# HISTORIC AND DESIGN REVIEW COMMISSION

**HDRC CASE NO:** 2019-632  
**ADDRESS:** 314 LAMAR ST  
**LEGAL DESCRIPTION:** NCB 528 BLK 1 LOT 4  
**ZONING:** R-5, H  
**CITY COUNCIL DIST.:** 2  
**DISTRICT:** Dignowity Hill Historic District  
**APPLICANT:** Timothy Patrick/FDN Home, LLC  
**OWNER:** 10X Properties Investments Series, LLC  
**TYPE OF WORK:** Rehabilitation, construction of a rear addition, and construction of a rear accessory structure  
**APPLICATION RECEIVED:** October 18, 2019  
**60-DAY REVIEW:** December 17, 2019  
**CASE MANAGER:** Edward Hall  
**REQUEST:**

The applicant is requesting a Certificate of Appropriateness for approval to perform rehabilitation, exterior modifications and to construct a rear addition at 314 Lamar. Within this request, the applicant has proposed the following:

NEW WORK  
SECOND FLOOR PLAN  
SCALE: 1/4" = 1'-0"

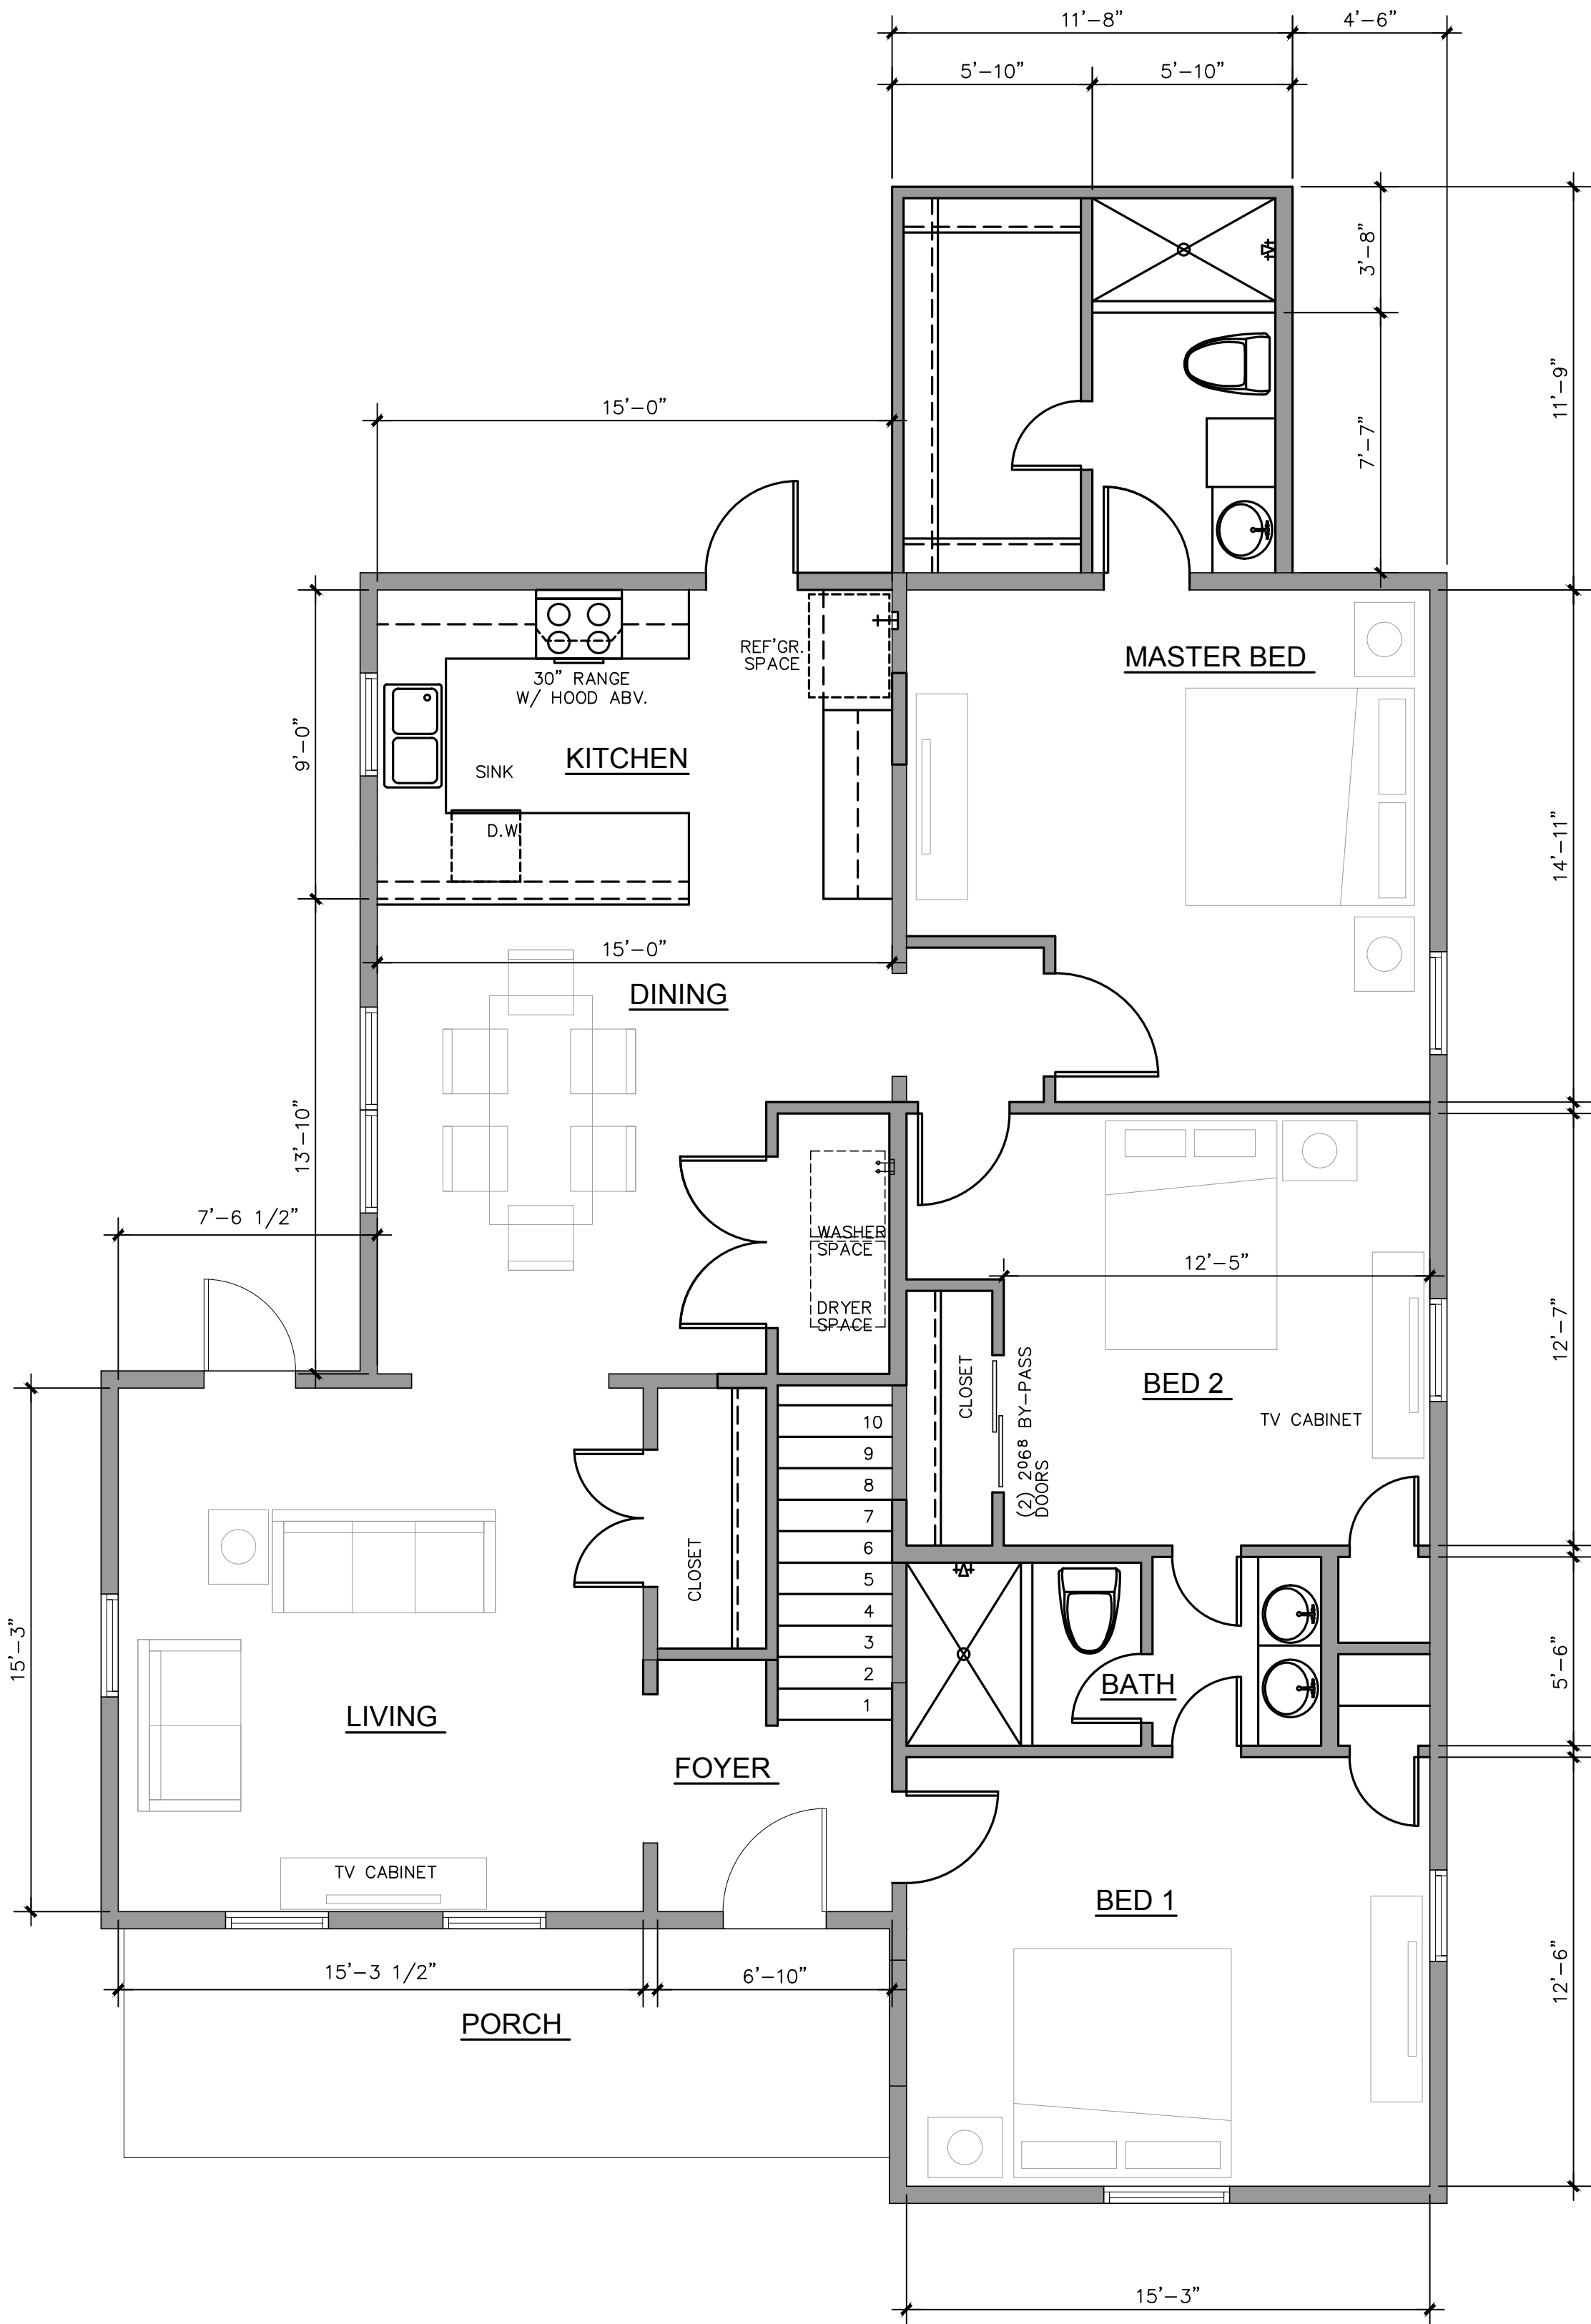
- f. **REAR ADDITION & ENCLOSED PORCH** – The applicant has proposed to construct a rear addition to feature approximately 300 square feet. The proposed addition will be located adjacent to a rear, covered porch that will be enclosed. This porch is inset and is within the primary roof structure. The Guidelines for Additions 1.A. states that additions should be sited to minimize visual impact from the public right of way, should be designed to be in keeping with the historic context of the block, should utilize a similar roof form and should feature a transition between the old and the new. Generally, staff finds the size of the proposed rear addition to be appropriate regarding its footprint; however, staff finds that the applicant should incorporate design elements that allow the enclosed porch to rear as a porch. Currently, the previous porch would only feature a rear door. Additionally, staff finds that an addition that features two stories in height may be more appropriate if it did not modify the historic structure's roof form.

- 3. Staff does not recommend approval of item #3, the construction of a rear addition based on findings f through k. Staff recommends that the applicant modify the proposed roof form, massing and architectural details to be more in keeping with those of the historic structure and that does not modify the roof form of the historic structure. Additionally, staff recommends that the applicant submit a line of sign study to determine the appropriateness of the proposed rear addition's height. The proposed rear addition should not been visible when viewed from the right of way.
